Site Accessibility Evaluation

Fire Station 4

Accessibility Evaluation

SUBJECT: Fire Station 4 Self-Evaluation

Finding: 2

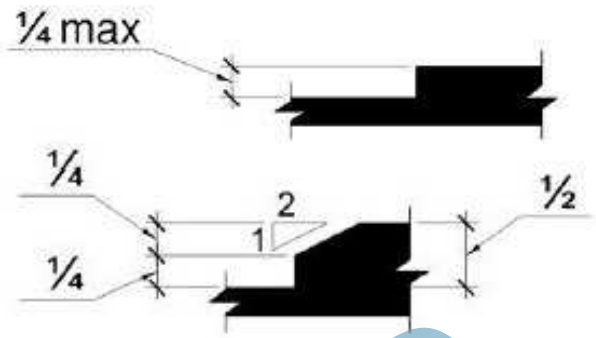
The walkway contains abrupt vertical edges and/or variations over a 1/4 inch.

There is 1" vertical lip where the sidewalk meets the asphalt driveway.

Remove and replace the end of the sidewalk. Patch asphalt as needed.

Finding: 3

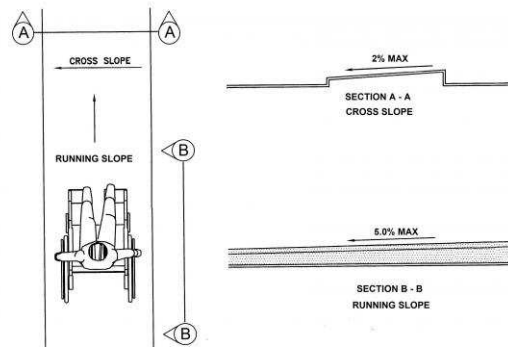
The accessible path of travel contains cross slopes greater than 2%.

The sidewalk portion of the driveway has cross slopes ranging from 2.5% to 4% (mostly 3%).

Remove and replace concrete as feasible and needed to maintain 2% cross slope.

Finding: 4

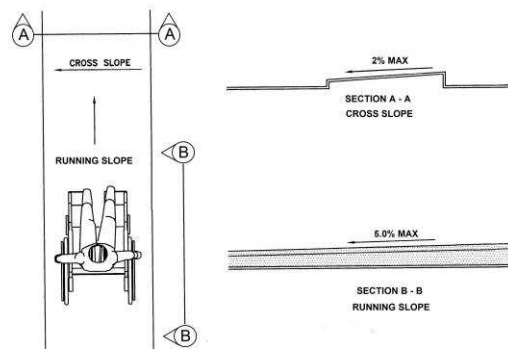
The accessible path of travel contains cross slopes greater than 2%.

The sidewalk on Southgate has 11 pads with cross slopes ranging from 2.3% to 5%.

Remove and replace concrete as needed to maintain 2% maximum cross slope.

Finding: 5

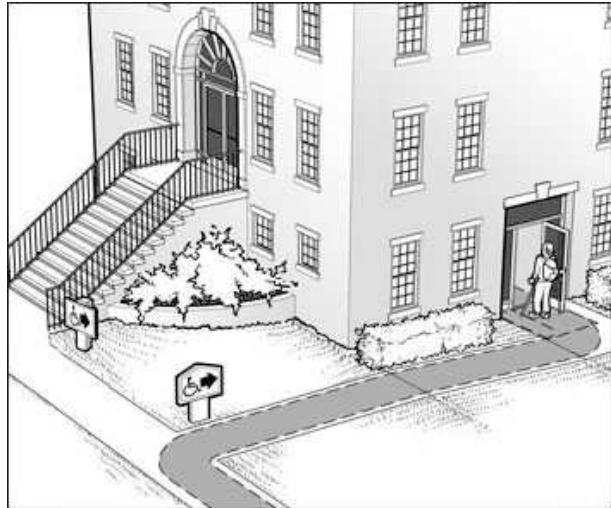
The building entrance is not located on an accessible route.

There is no accessible entrance to the front door.

Add about 15' of sidewalk to the front door adjacent to the drive.

Finding: 6

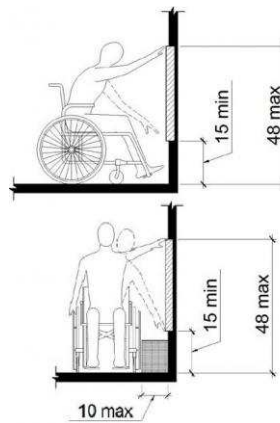
The door bell is positioned too high for either a side or front approach.

In addition to being mounted too high, the door bell is mounted over an ash can.

The door bell is mounted at 57-1/2".

Lower the door bell to 48" maximum, and move the ash can to accommodate a 30" by 48" area for approach.

Finding: 7

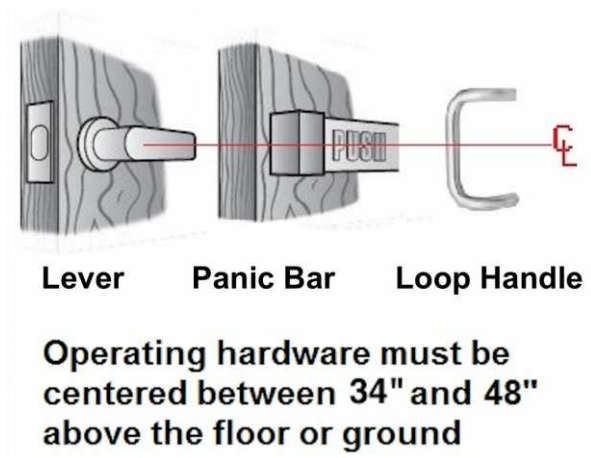
The door/gate operating hardware is not accessible.

The door hardware into the front entrance is a knob.

Replace the knob with lever-style hardware.

Finding: 8

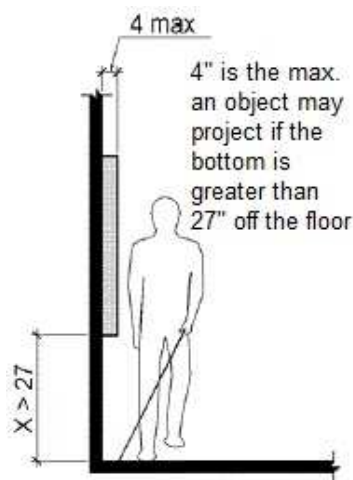
The ashcan projects more than 4 inches into the circulation path.

The ash can projects into the path of travel more than 4".

Remove ashcan

Finding: 9

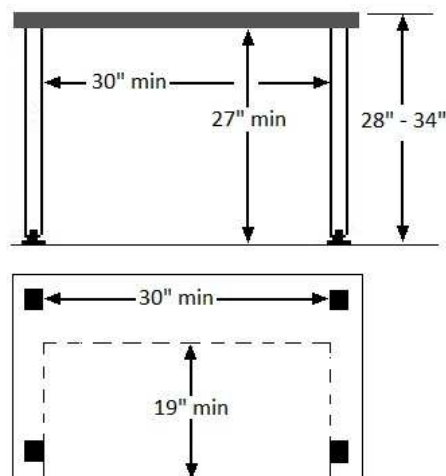
The top of the table surface is not within the compliant height range.

The table in the bay area is 37" to the top edge.

No action needed unless this table is used for public functions.
